**Economic and Social Council**Distr.: General
2 February 2015

Economic Commission for Europe**Inland Transport Committee****World Forum for Harmonization of Vehicle Regulations****Working Party on Lighting and Light-Signalling****Seventy-third session**

Regulation No. 48 (Installation of lighting and light-signalling devices) –**Other proposals for amendments to Regulation No. 48****Proposal for Supplements to the 04, 05 and 06 series of amendments to Regulations No. 48 (Installation of lighting and light-signalling devices)****Submitted by the expert from France***

Figure 1. GTB Study (GRE-71-32) of the glare and loading conditions for the different light source types

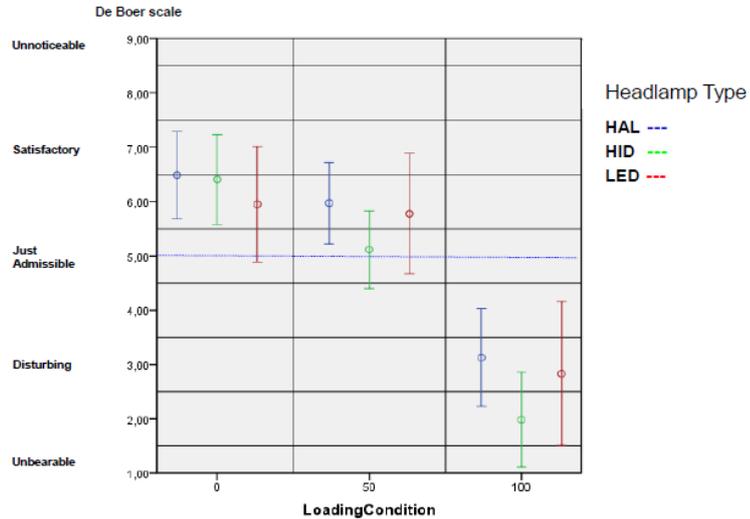
1. The study by GTB following the night test held in Klettwitz, in March 2012 showed that the light source type does not influence the glaring of other road users (see Figures 1 and 2 below, GTB conclusions). Thus, there is no reason to require an automatic levelling device for all headlamps with light emitting diode (LED) light sources, whatever the luminous flux of the light source. This requirement is not needed and costly. The use of automatic levelling devices for all types of LED headlamps is an advancement in the development of this technology.

Figure 2. GTB conclusions (GRE-71-32)

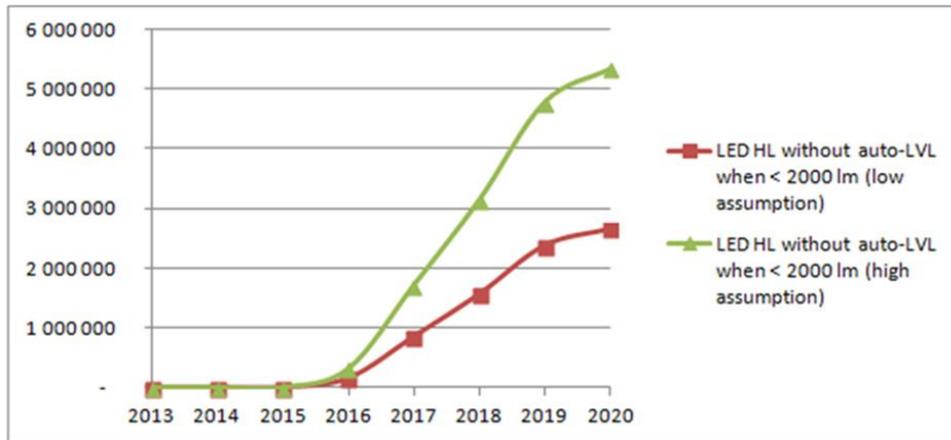
- Results of Discomfort Glare and disability glare show clearly, that the behaviour of the vehicle is the important factor for deciding on levelling needs
- Light source is not significantly contributing
- Pitch angle is a qualified parameter for new regulation criteria

Figure 4. Evaluation of savings on CO₂ emissions generated by the proposal

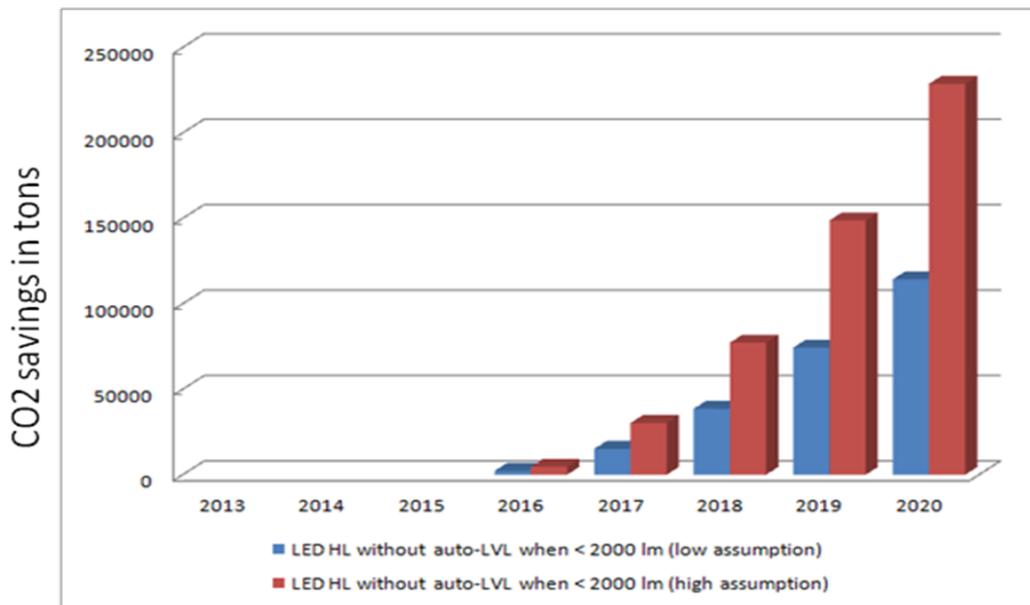
- Energy saving: LEDs have a consumption of roughly 30/40W for both headlamps in comparison with 137W for the current technology. According to the technical guidelines of the European Union (EU), it implies a decrease of CO₂ emissions by 1.0 g (based on the data of the EU technical guidelines of February 2013). As a consequence, if this proposal is adopted and the requirement for automatic levelling is the same for LEDs as for the other light source types, in 2020 in Europe, there will be between 2.6 and 5.2 million more cars equipped with LEDs than if the Regulation remains unchanged and, as a consequence, there will be a reduction in CO₂ emissions of between 110,000 and 220,000 tons per year (see Figures 3 and 4 below).

- Hypothesis:
 - LED headlamps save 1g CO₂ /km.
 - Average mileage : 15000km/year.

Between 110,000 and 220,000 tons of CO₂ saved per year in 2020 in Europe.
